SERVICE BULLETIN: Fly-boom head stock EO400-401 Issue 2

Details:

In-service wear/ cracking has been detected on the bucket bracket at the lower pivot point (circled in red on page 2). This may affect the lifts listed below:

FLYBOOM 120° FOR ETL
L3
VERSION 2016

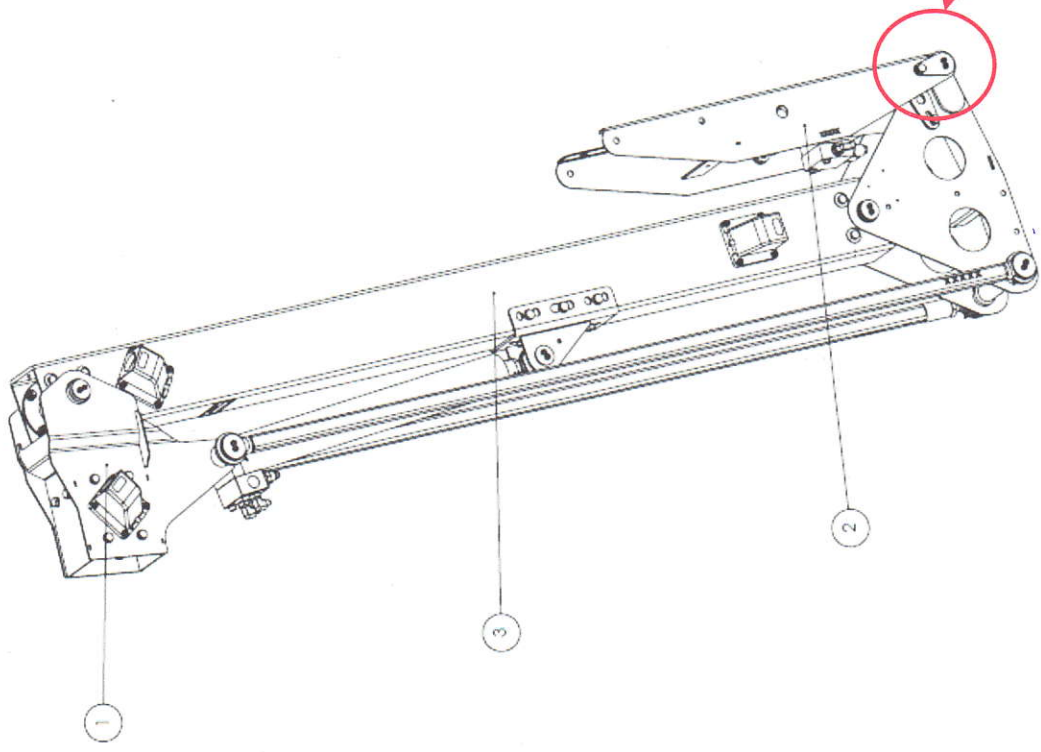
Operators of the lifts listed above are to immediately, upon receipt of this Service Bulletin, inspect the bucket bracket (Item 2 overleaf) for signs of wear/ cracking around the lower pivot point. If there are signs of wear, please remove the vehicle from operation and report your finding to the contact detailed below.

A Versalift in-service inspection/ modification will be carried out to all lifts, as listed above, within 1 month of the date of this Service Bulletin. The Versalift Service team will contact you in due course to schedule these works.
